Product: TV's with Digi Basic chassis

Television No. 1/97

Technical Services / Information

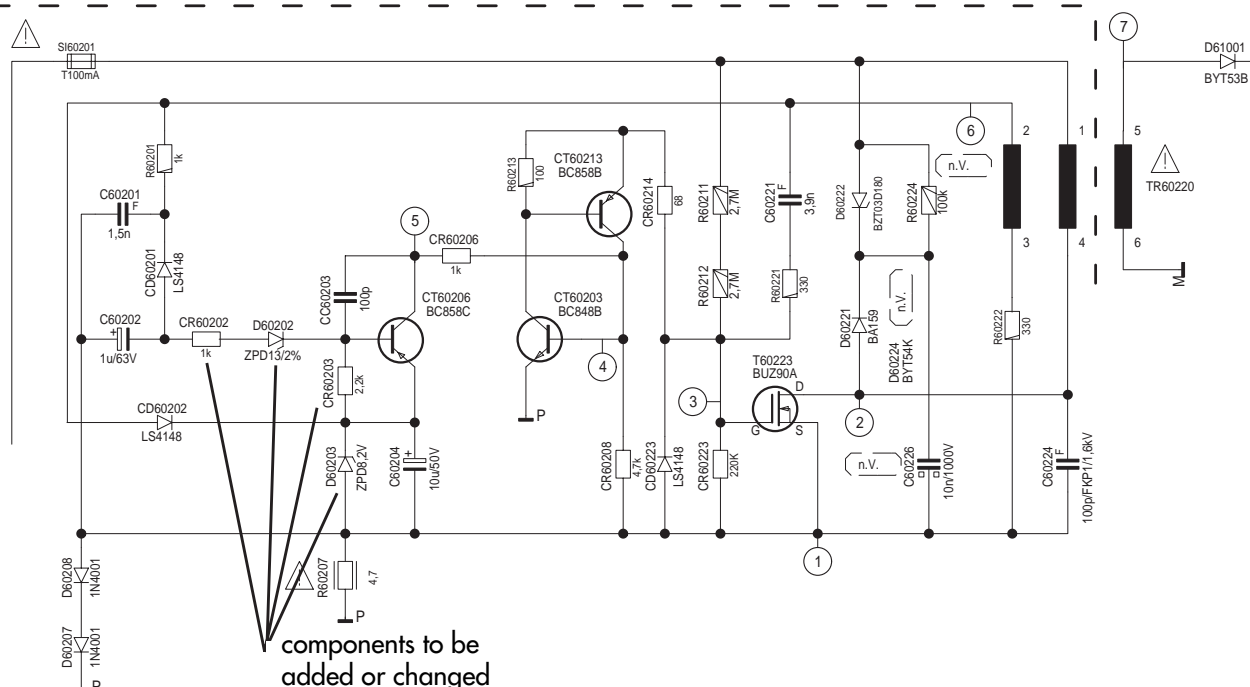
Brown colouration of the circuit board near the diode D 60222 BZT 03D180. Simultaneously the "+Eco" voltage is approx. 5V too high.

Coincidence of unfavourable component tolerances.

Carry out the following changes in the stand-by mains stage:

- Change the Z-diode D 60203 from ZPD 9.1V to 8.2V.
- Change R 60202 from 68 k Ω to 1 k Ω .
- Connect an additional Z-diode ZPD 13 in series with R 60202. Connect the cathode of the diode to the base of the transistor CT 60206.
- Check the rating of the resistor CR 60203 to be 2.2 k Ω .

Television No. 2/97

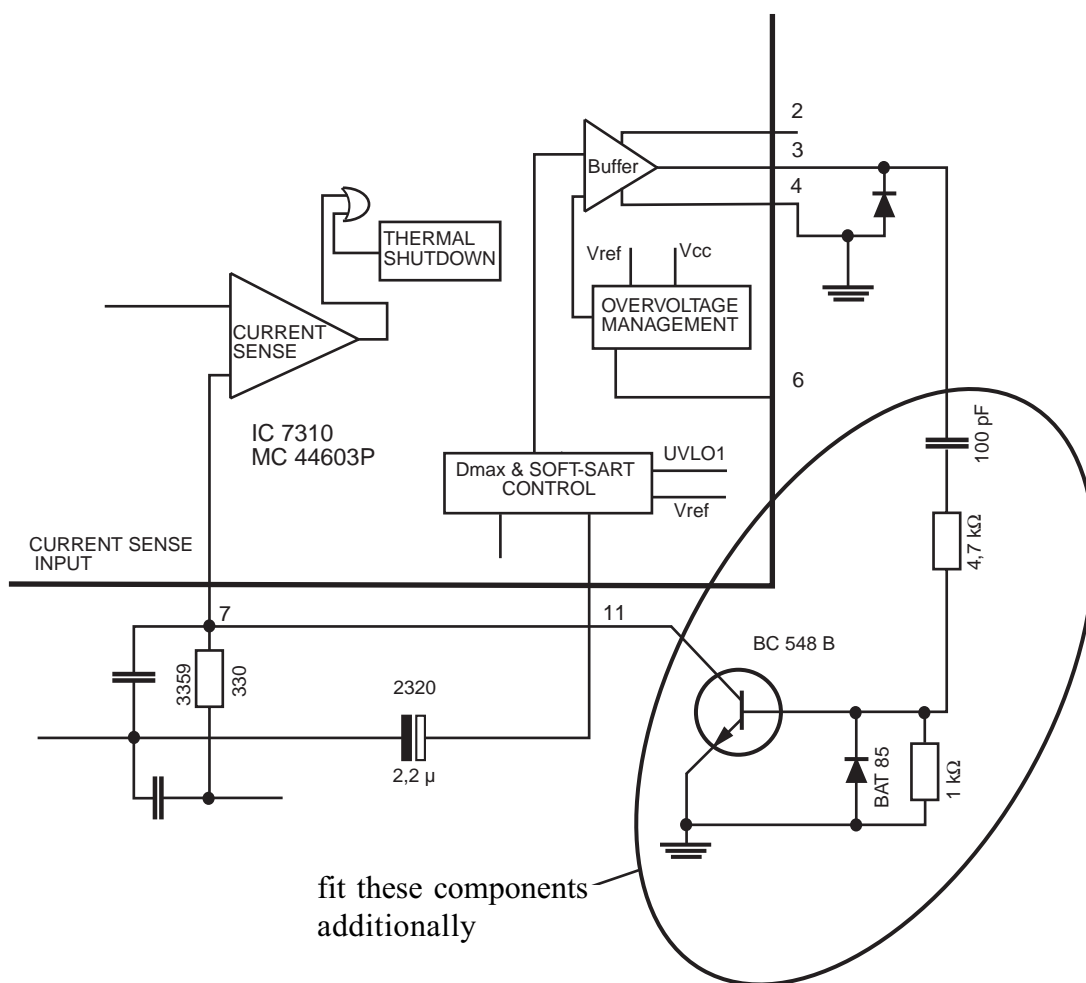
Mains voltage dependent chirp audible in stand-by mode.

Fit an additional transistor stage as shown below into the power supply unit at IC 7310 (MC 44603 P).

Television No. 3/97

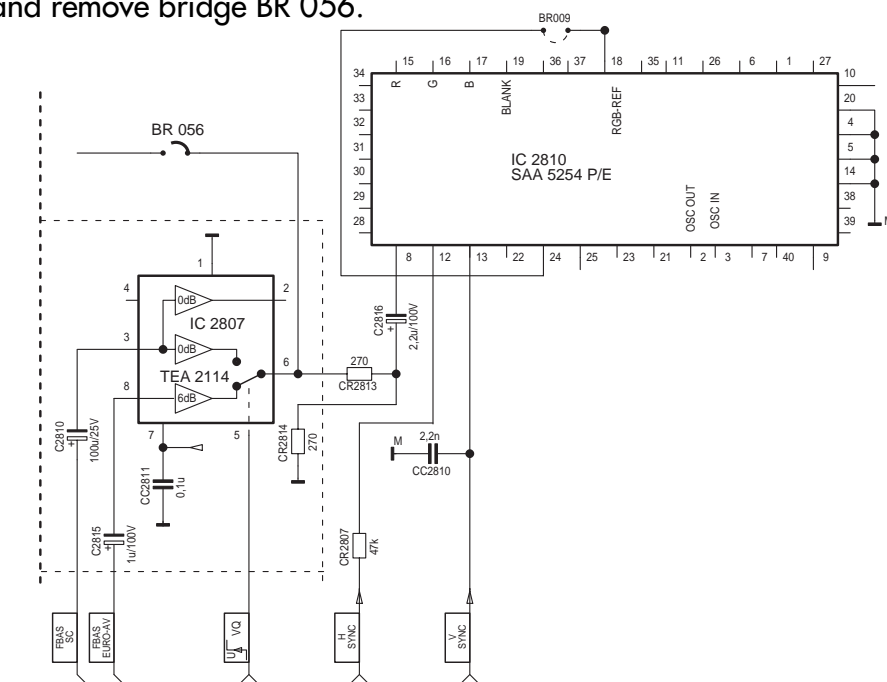
Teletext operation is not possible in "AV" programme position.

The video switch-IC 2807 (TEA 2114) is not fitted in 37 cm television receivers.

Retrofit the following components:

In addition, change the polarity of 2.2 μ F electrolytic capacitor C 2816 (negative terminal to pin 8 of IC 2810) and remove bridge BR 056.

Serial No 5/97

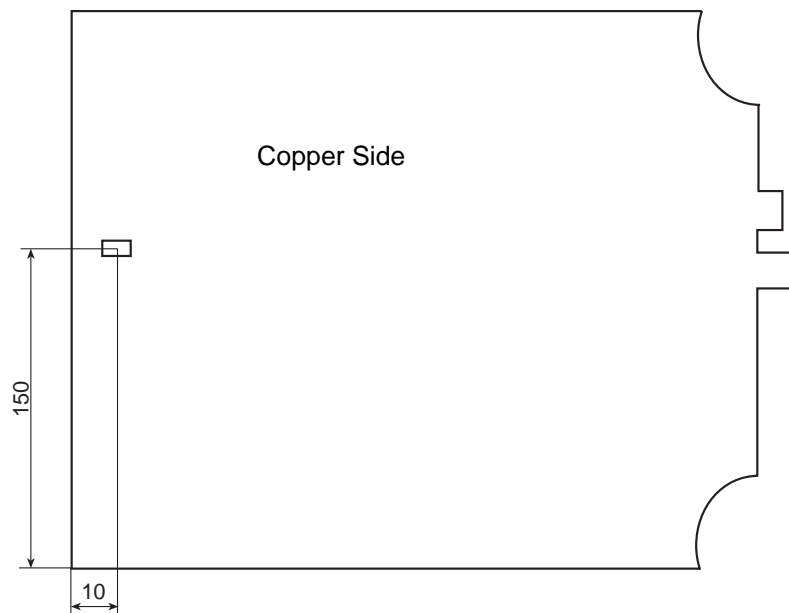
Despite the modifications carried out according to our TV Service Information 9/96 the television sets switch occasionally to Standby after a prolonged time of operation.

Temperature drift of the +E operating voltage by about 0.2 to 0.3V caused by Z-diode CD 61023. Consequently, IC 34015 TDA 8374 switches off with sudden black/white changes in the picture content or changing scenes.

The position of the Z-diode is X=10, Y=150. Unsolder this diode and insert a SMD resistor 1206 1.2Ω 1% in this place.

Serial No 6/97

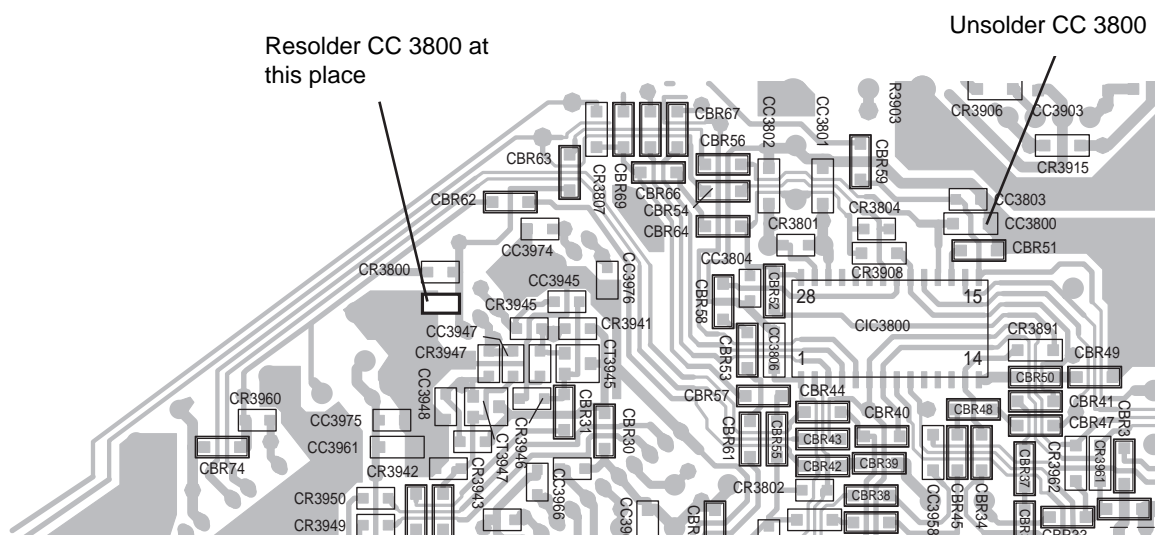
The sound disappears suddenly during the reception of a satellite programme and is audible again only when changing the programme or switching the TV off and on again.

IC MSP 3400 on the SAT Module hangs up by static charges entering the Reset input of the IC.

Unsolder the SMD capacitor CC 3800 from its place on the SAT Module and resolder it at the place indicated on the figure below.

Serial No 9/97

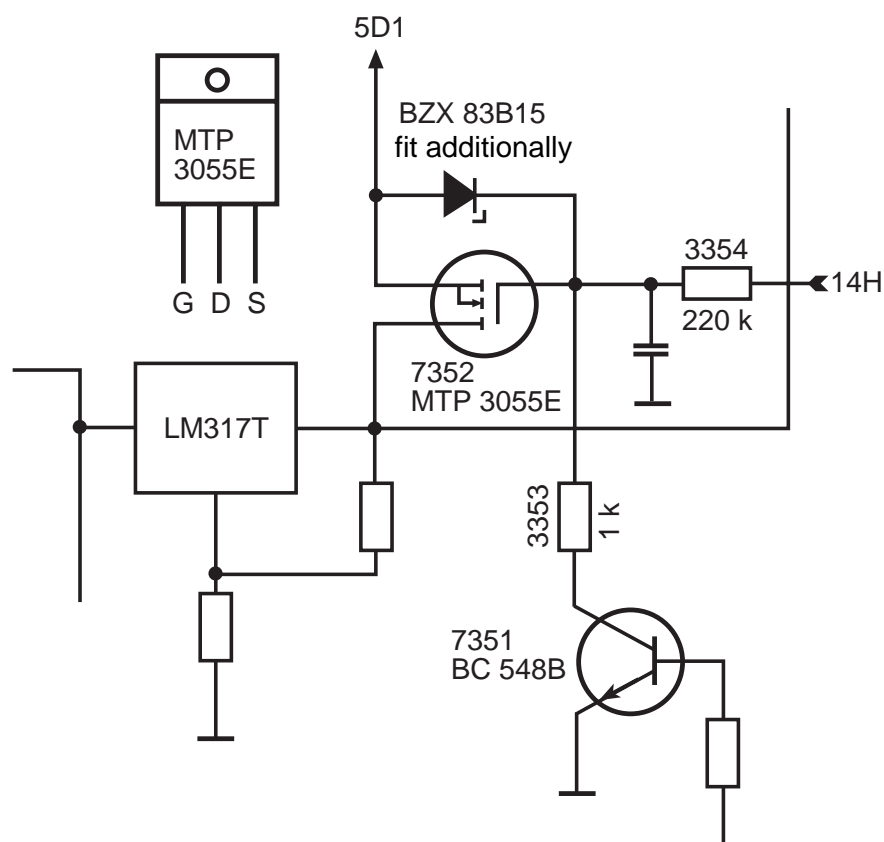
TV Recorder does not operate.

Defect in transistor 7352 (MTP 3055E) caused by static discharges in the TV Recorder.

Fit an additional Z-diode BZX 83B15 between gate and source to suppress voltage peaks at the gate.

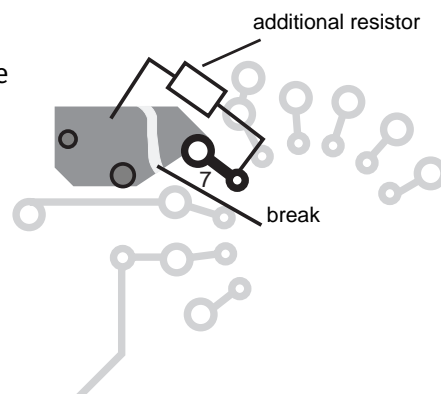
Failure of the RGB output stages (picture tube panels 29305-022.16 and -022.17) or of the teletext function.

The semiconductors are destroyed by high-voltage sparks within the picture tube.

On the picture tube panels -022.16/-022.17, insert an additional 1.5 k Ω composite carbon resistor (do not use a carbon film resistor!) into the circuit path to the screen grid connection of the picture tube socket. Ensure that the break is 2mm wide at least (see figure) to avoid sparking.

Serial No 14/97

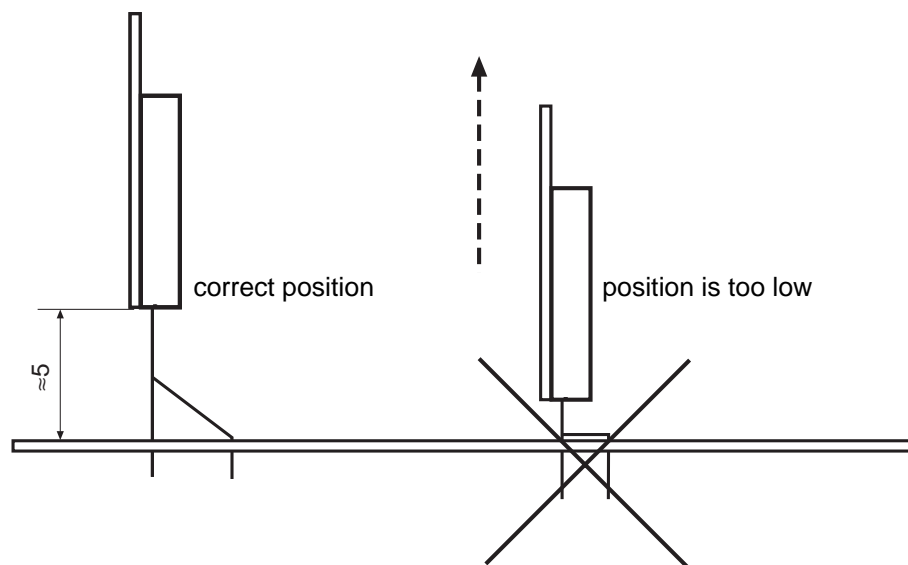
Vertical output stage TDA 4173 fails or thin white lines similar to retrace stripes are visible.

Inherent instability of the vertical output stage IC TDA 4173 AF.

- Should above mentioned symptoms appear do not fail to exchange TDA 4173 AF and solder additionally a 1 nF foil capacitor from pin 1 and from pin 7 each to pin 4 (-K voltage) on the copper side.
- Check the mounting position of the vertical output-IC. If the position of the IC is too low, the pins may temporarily come into contact with the chassis connection on the upper side causing the IC to fail. Additionally, the circuit may already be damaged by the building up force of pressure resulting in a long-term failure. Therefore replace TDA 4173 AF also if it has not been fitted correctly!

Serial No 16/97

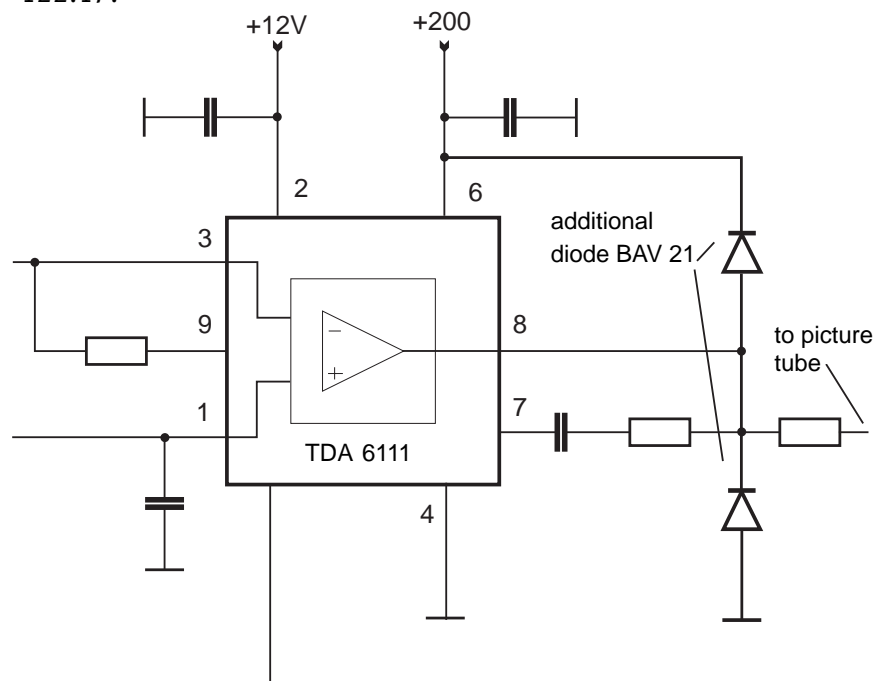
Failure of the RGB output IC's TDA 6111.

The RGB output IC's are destroyed by high voltage sparks.

Directly from the outputs (pin 8) of the three output IC's TDA 6111 connect one additional diode BAV 21 each to chassis and one diode each to the +200 voltage (see figure).

The three diodes which are to be connected to chassis are to be soldered on to the copper side from pin 8 to pin 4 (anode to pin 4).

Serial No. 4/98

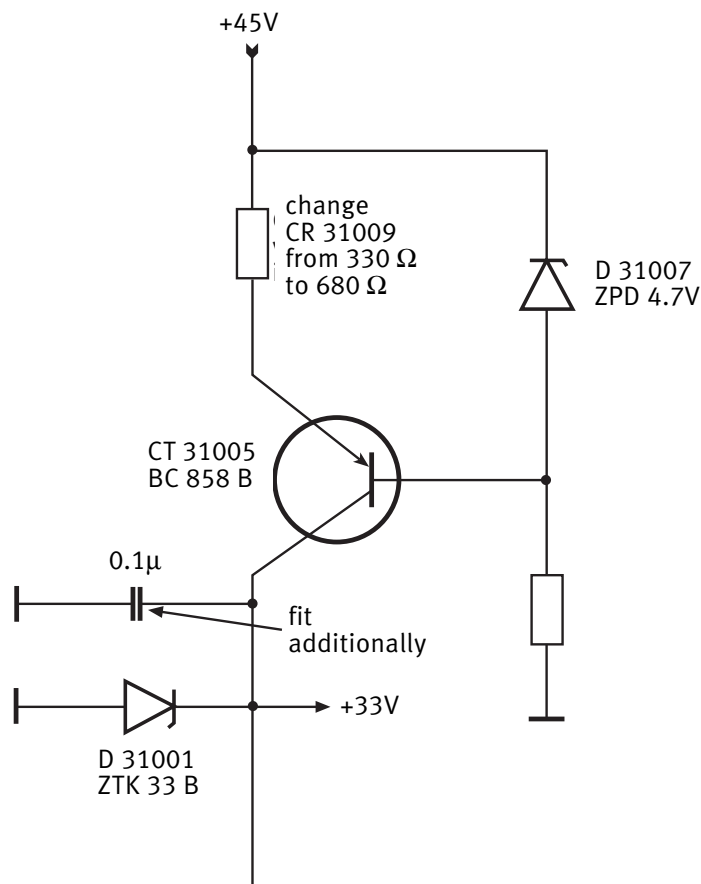
Failure of diode D 31001 ZTK 33B caused by too high a Zener current.

On replacement of the the Z-diode ZTK 33B, change additionally the SMD resistor CR 31009 from 330 Ω to 680 Ω 5% (structural shape 0805) and solder an additional 0.1 μ F foil capacitor in parallel with Z-diode ZTK 33B.

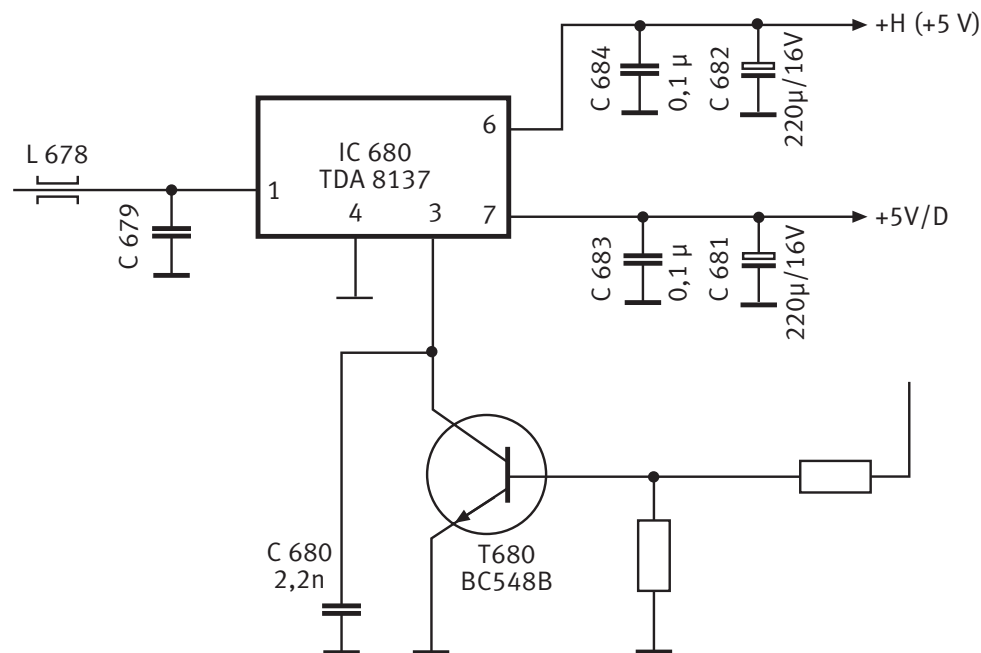
Tearing of the displayed menus and teletext pages.

Failure of the capacitors C 683 and C 684 of 0.1 μ F each.

Change the electrolytic capacitors C 681 and 682 of 220 μ F/16 V each in addition to the capacitors C 683/684.

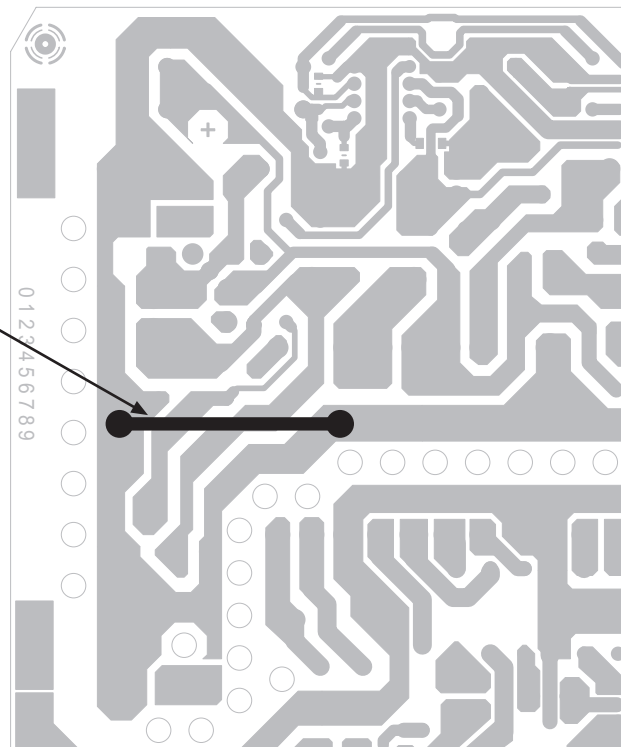
The interference level can be reduced noticeably by soldering in an additional ground-to-ground connection.

Solder an insulated wire of approx. 35mm (2.5mm²) in length on to the solder side of the mains supply section (between pos. R60007 and C60001) as shown below. This additional wire is used to short-circuit the ground loop which has been found to be the source of interference.

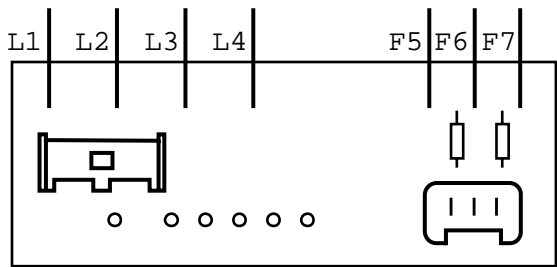
- changed yoke connections:
The figure below shows the connections of the deflection unit for the new picture tubes A 68 ESF 002X143 part no. 8300 068 24300 and A 68 ESF 202X143 part no. 8300 068 20400.

A 68 ESF 002X43 A 68 ESF 202X43	A 68 ESF 002X143 A 68 ESF 202X143 An existing seagull correction board is to be removed. The yoke connecting leads are soldered directly to the deflection unit (see figure).
A 68 ESF 002X043 A 68 ESF 202X043	A 68 002X143 A 68 202X143 No change. Connect the picture tube as shown in the figure.

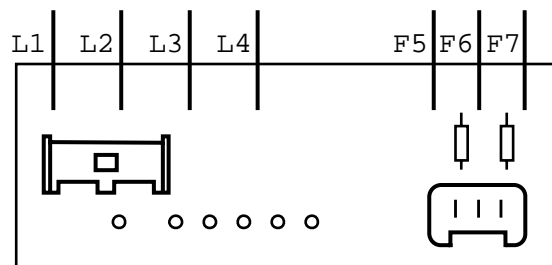
The figure below shows the connections of the deflection unit for the new picture tubes A 68 ESF 002X111 and A 68 ESF 202X111.

A 68 ESF 002X11 A 68 ESF 202X11	A 68 ESF 002X111 A 68 ESF 202X111 An existing seagull correction board is to be removed. The yoke connecting leads are soldered directly to the deflection unit (see figure).
A 68 ESF 002X011 A 68 ESF 202X011	A 68 002X111 A 68 202X111 No change. Connect the picture tube as shown in the figure.

Serial No. 2/99

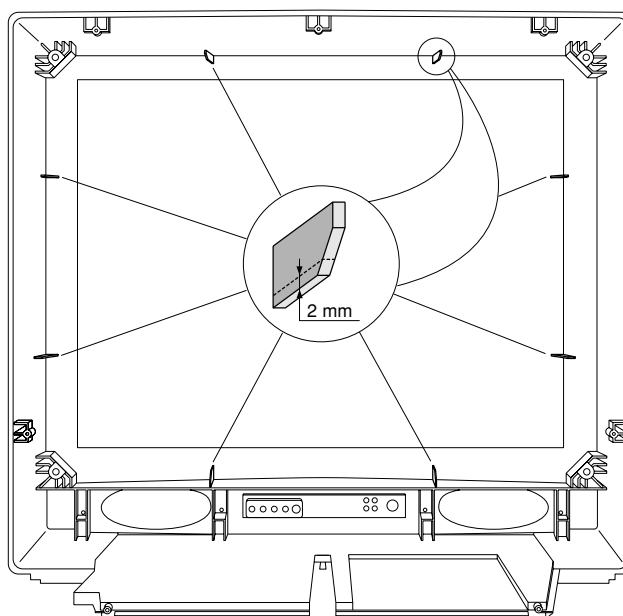
Due to the slightly larger overall dimension, the picture tube touches the fixing ribs within the cabinet. Consequently, when changing the tube, these ribs must be cut by about 2mm (see figure).
